SUBJECT: Nine Mile Point Nuclear Station
Unit No. 2; Docket No. 50-410

Response to Request for Additional Information:
Implementation of ARTS/MELLLA (TAC No. MD5233)

**RESPONSE TO REQUEST FOR ADDITIONAL INFORMATION
REGARDING IMPLEMENTATION OF ARTS/MELLLA
NON-PROPRIETARY VERSION**

Table 7b-1
Calculated ODYSY Decay Ratios along the Generic OPRM Armed Region Boundary

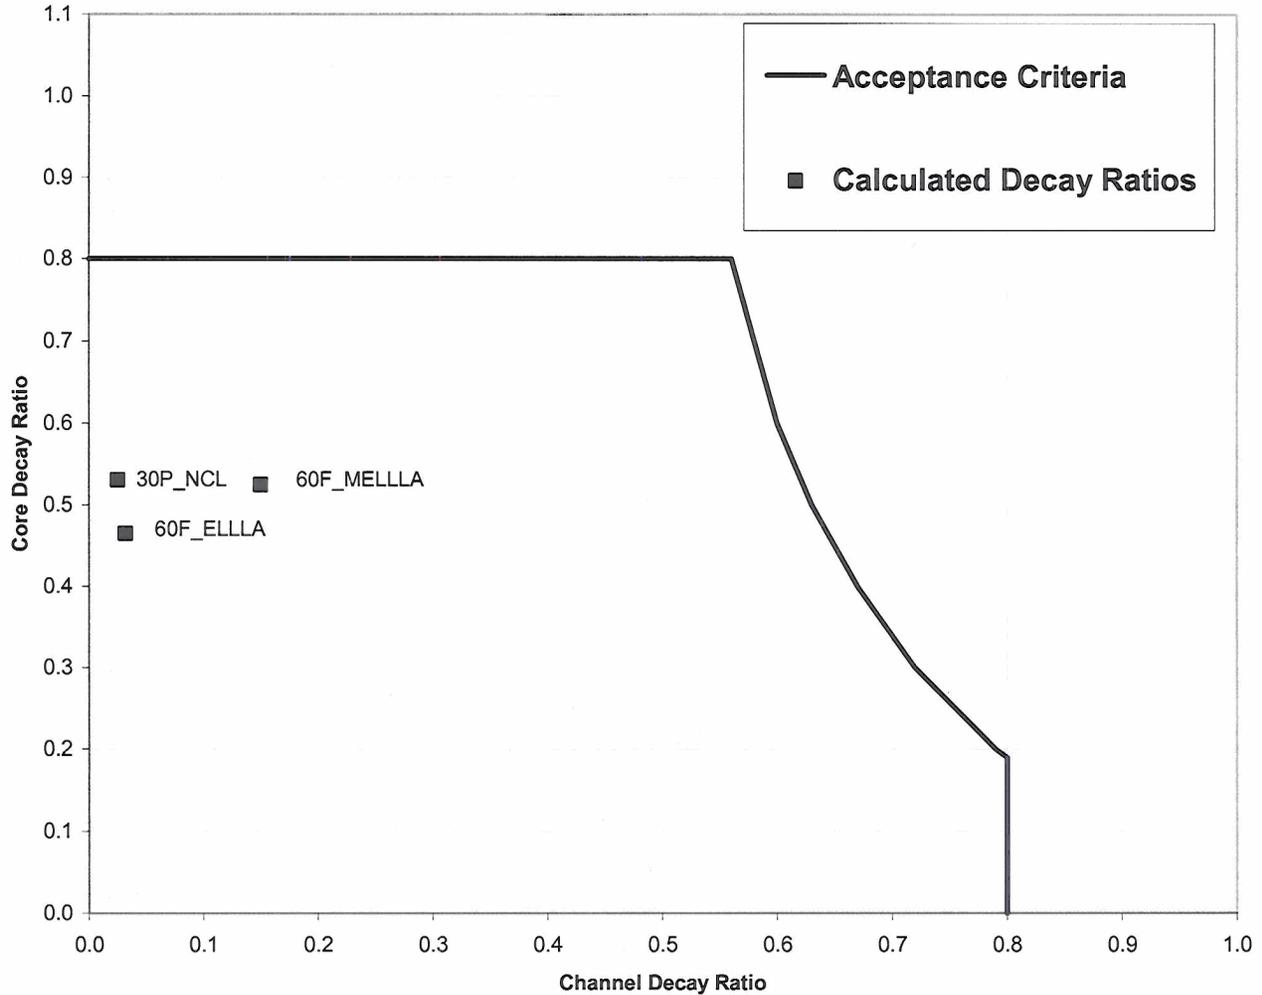
The OPRM armed region of the power/flow map was generically defined. The ARTS/MELLLA operating domain, however, allows for operation at certain powers off the rod line for that power. Provide an analysis of the core and channel decay ratio at a few points along the OPRM armed region boundary using an approved NRC method (such as ODYSY). Use the “dog-bite correlation” to draw conclusions regarding susceptibility to regional mode oscillations. Based on the analysis, discuss (1) any conservatism in the selection of the OPRM armed boundary, and (2) the impact of rod patterns off the rod line associated with that power on core wide stability.

The OPRM Armed Region is generically defined as $\geq 30\%$ rated core power and $\leq 60\%$ rated core flow on the power/flow map in the Option III licensing topical report, “Reactor Stability Detect and Suppress Solutions Licensing Basis Methodology for Reload Applications,” NEDO-32465-A, August 1996. Based on experience with actual instabilities and decay ratio (DR) calculations, instabilities above 60% rated core flow are not expected. Similarly, instabilities occurring below 30% rated power are also not expected. However, if an instability were to occur below 30% rated power, the instability would not be expected to grow large enough to threaten the SLMCPR. This expectation is due, in part, to the large MCPR margin that exists at low power.

Core and channel decay ratios at various points along the generically defined OPRM Armed Region boundary are provided in Table 7b-1 and plotted on Figure 7b-1 to demonstrate their relationship to the dog-bite acceptance correlation. The points on the 60% flow line were selected to show the impact on stability of the increase in operating domain associated with the implementation of MELLLA. These decay ratios are calculated using the NRC approved ODYSY code (Licensing Topical Report, “ODYSY Application for Stability Licensing Calculations,” NEDC-32992P-A, July 2001). The analysis completed for this RAI Response used the Nominal Natural Circulation Line (identified as Low Recirc Pump Speed Both FCVs Min. Pos. in Figure 6-2 of Attachment (7) of the LAR) and demonstrates that the backup stability protection (BSP) boundaries shown in Figure 6-2 are conservative.

The calculated channel decay ratios for the points shown are well below 0.56, which is the criterion used to establish susceptibility to regional oscillations. In addition, the core decay ratios are significantly below the 0.80 acceptance criteria for core wide oscillations. Based on these low decay ratios, it is highly unlikely that either regional or core wide mode oscillations will occur outside the OPRM Armed Region boundary near the points shown.

Figure 11e-1 - Downcomer Water Level

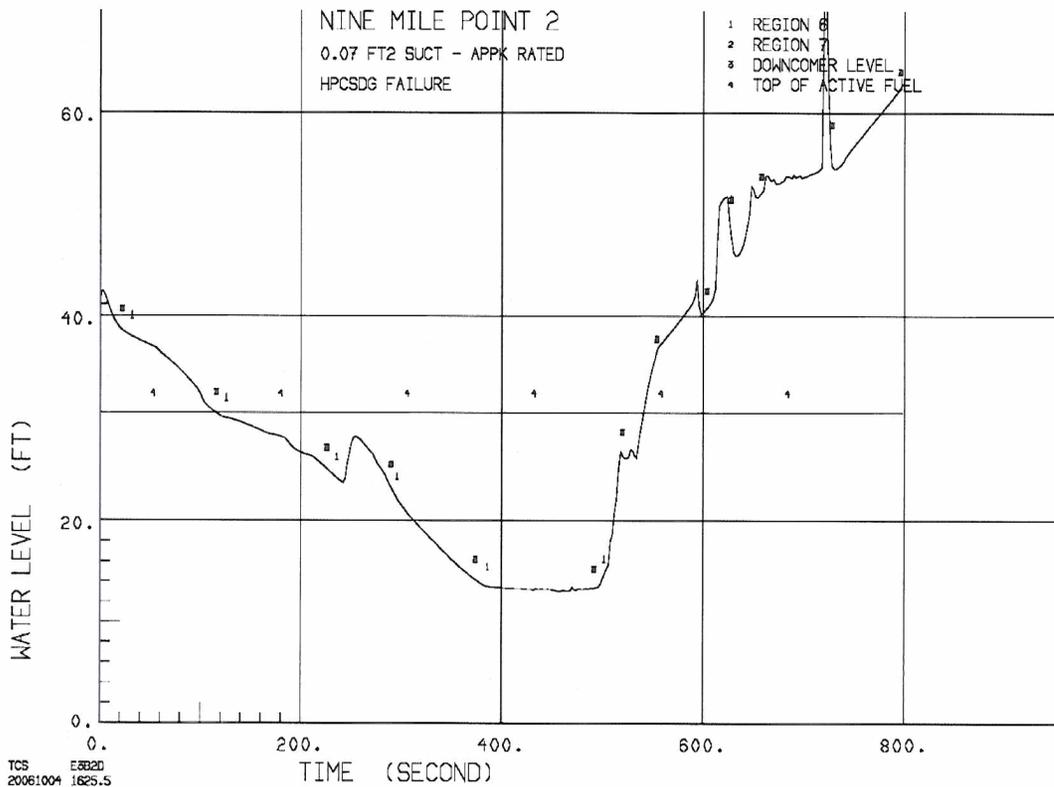
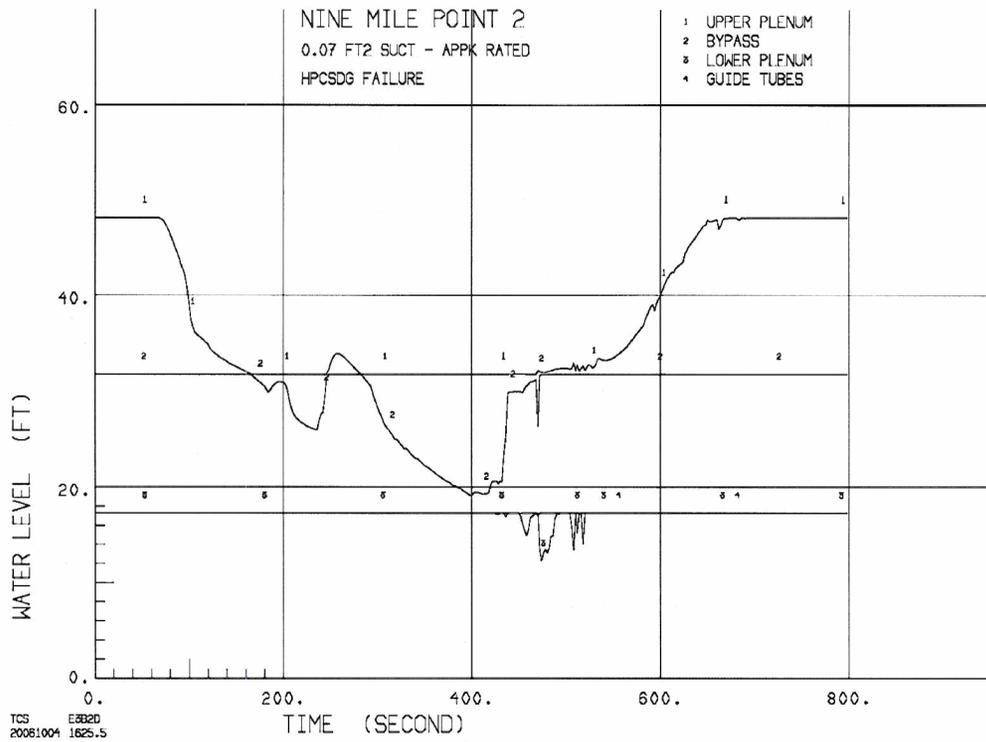
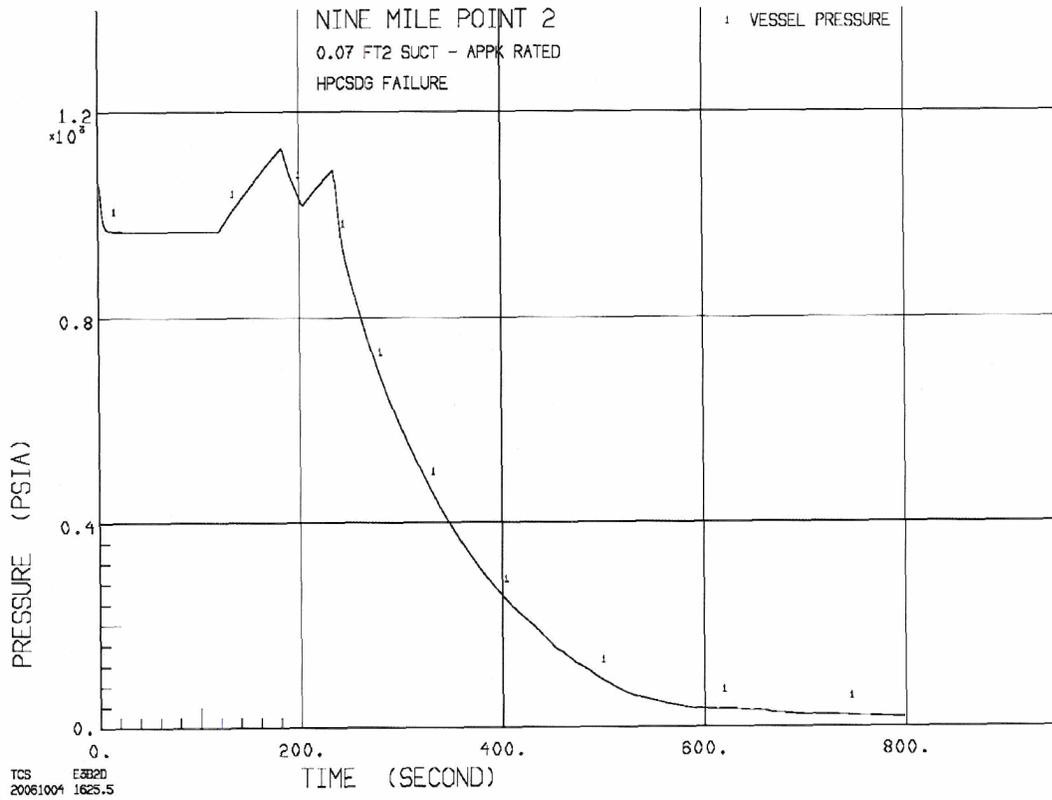
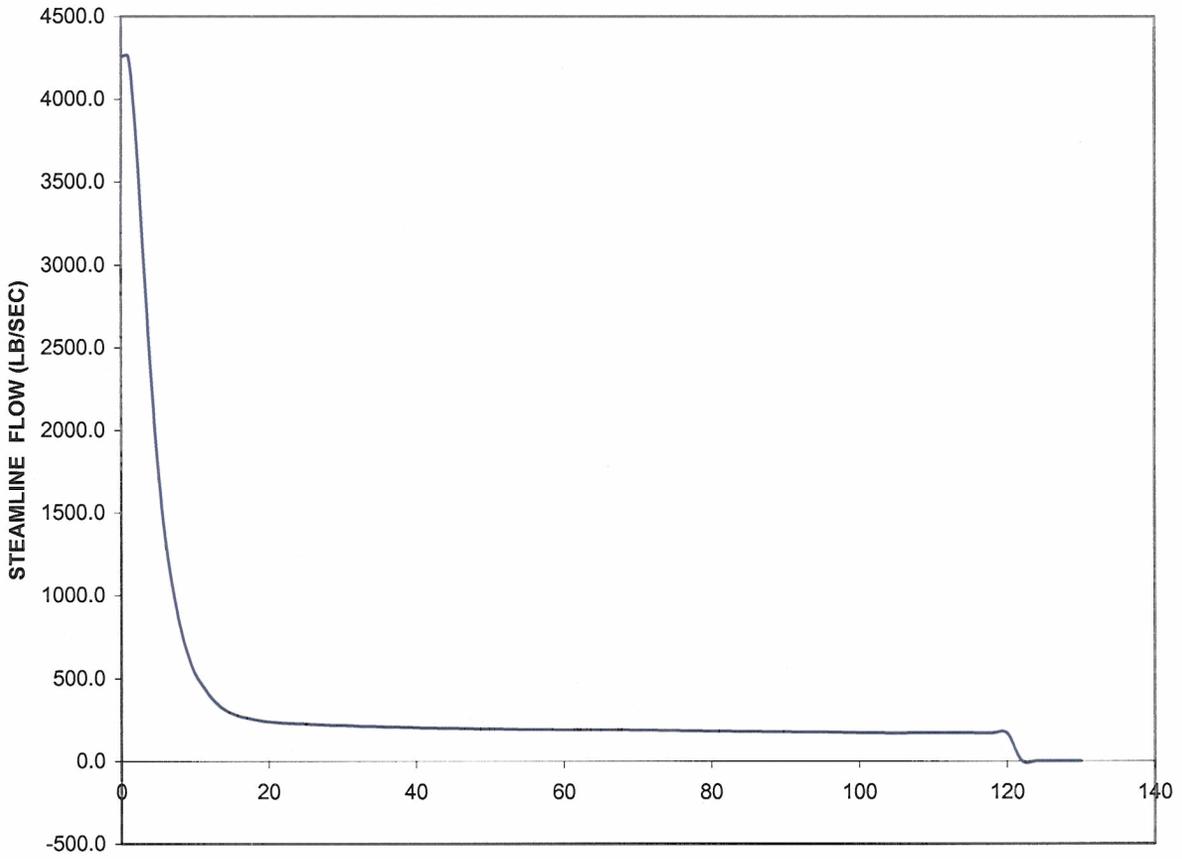
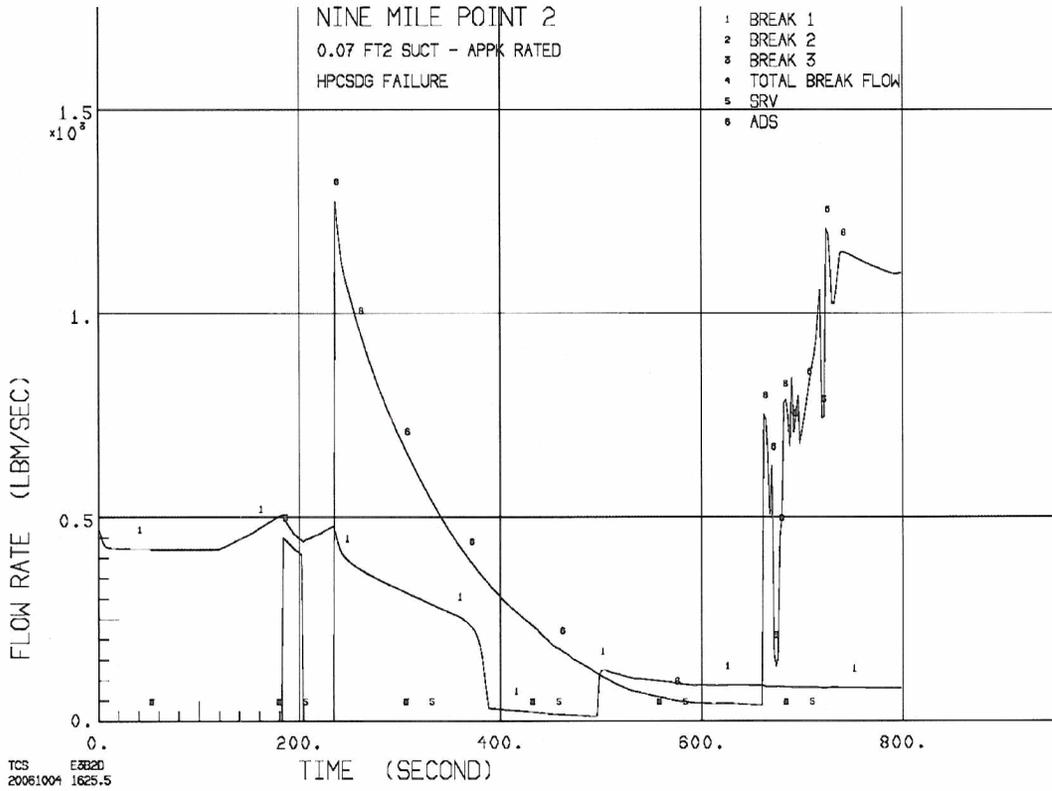
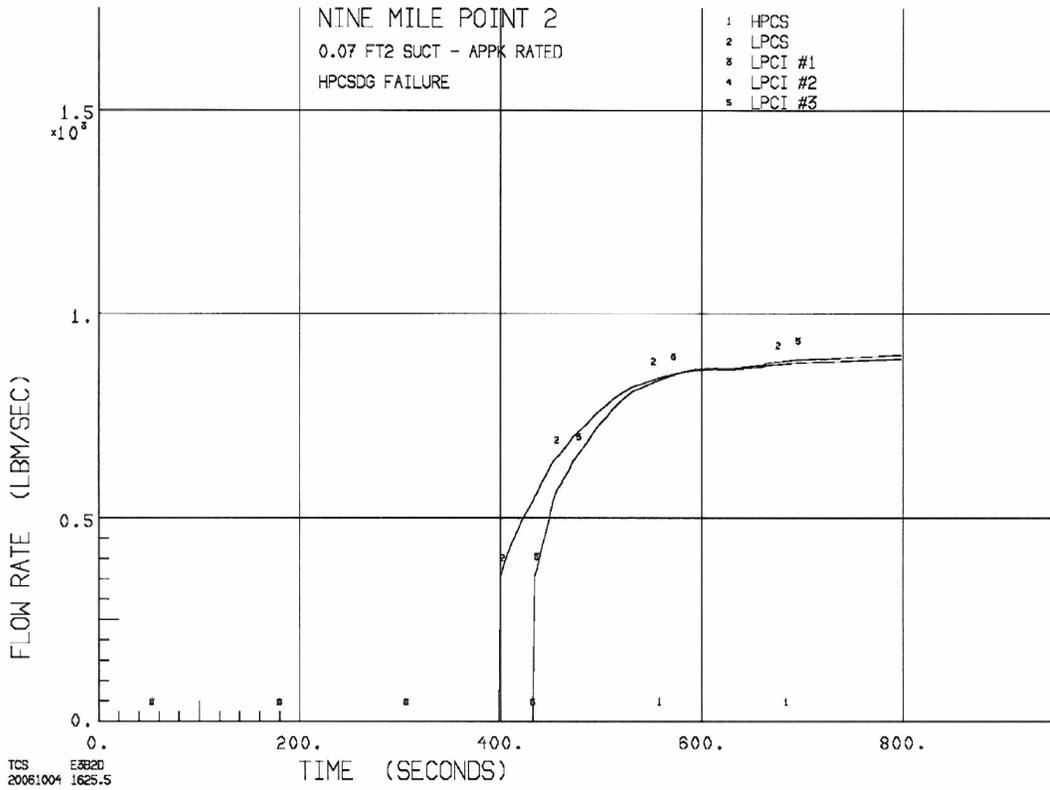
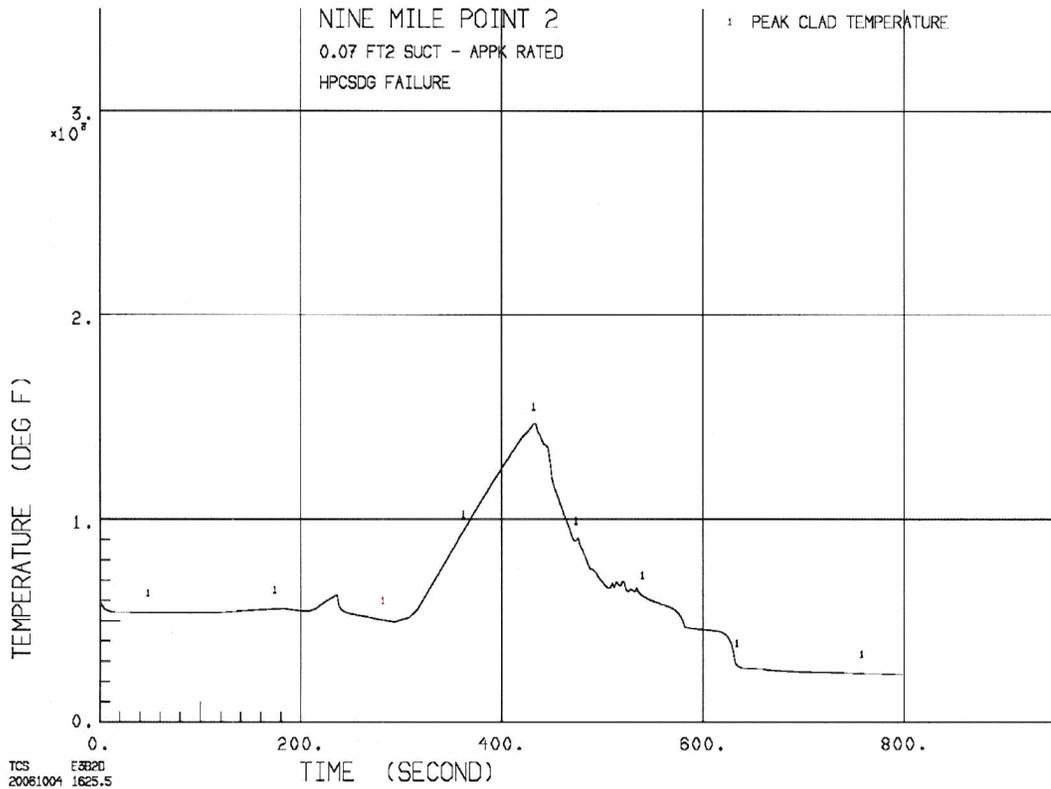
For the limiting licensing basis LOCA scenario, provide figures showing the transient MCPR, downcomer water level, collapsed liquid bypass level, system pressures, steam line flow, break flow, automatic depressurization system flow, high pressure core spray flow, low pressure core spray flow, low pressure coolant injection flow, total of all egress flows, total of all injection flows, and PCT.

MCPR is calculated to confirm initialization of the power distribution, set to the MCPR limit. It is important in the DBA break, which is affected by early boiling transition; however, the limiting licensing basis LOCA scenario reported for NMP2 is a small break case. For small breaks, the core flow coastdown is slow enough to prevent early boiling transition before core uncover. The MCPR parameter is not relevant to this limiting basis LOCA scenario.

Figures for the remaining parameters are provided for the Small Break 0.07 ft² Rated case that is the base for the limiting PCT.

Figure 12a-1

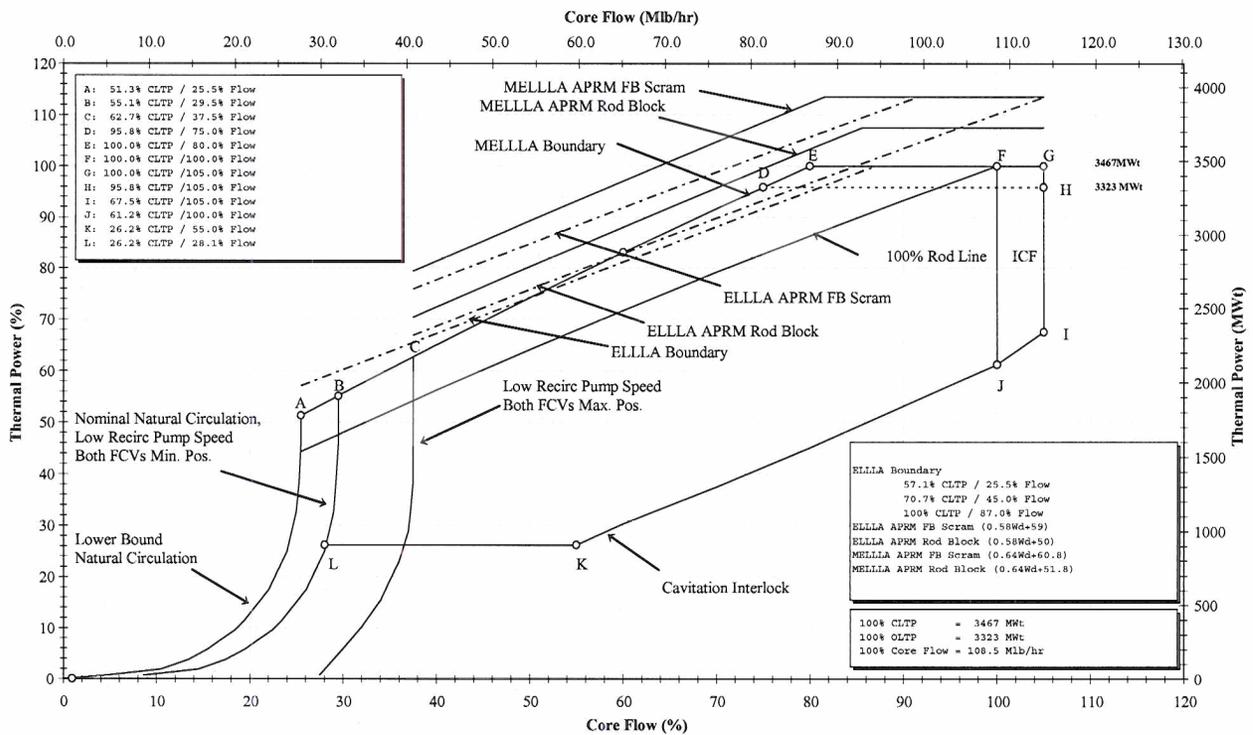
Provide a figure on the same scale as Figure 1-1 of Attachment (7) of your request that shows and defines the previous and updated average power range monitor (APRM) rod block trip and SCRAM setpoints, the proposed MELLLA operating domain and APRM setpoints, and the Extended Load Line Limit Analysis operating domain and APRM setpoints.

A power/flow map with the requested information is provided in Figure 12a-1. At core flows less than Line "C" (Low Recirc Pump Speed, Both Flow Control Valves [FCVs] Max Position) the flow-biased (FB) setpoint curves drop sharply toward a continuation of the Lower Bound Natural Circulation Line ("A") as a result of the correlation of drive flow versus core flow. In the ELLLA operating domain, there is no APRM Rod Block clamp setpoint; as such, the ELLLA APRM Rod Block setpoint line is shown extending to 105% core flow. The ELLLA APRM Flow Biased Scram, and the MELLLA Flow Biased Rod Block and Scram setpoint lines are shown as a combination of the Flow Biased nominal trip setpoints and clamp values. The APRM Flow Biased Scram clamp is not modified for MELLLA.

Note that the designators for the curves beginning at points “A” and “B” have been revised from those used in Figure 1-1 of Attachment (7) of the LAR to enhance clarity.
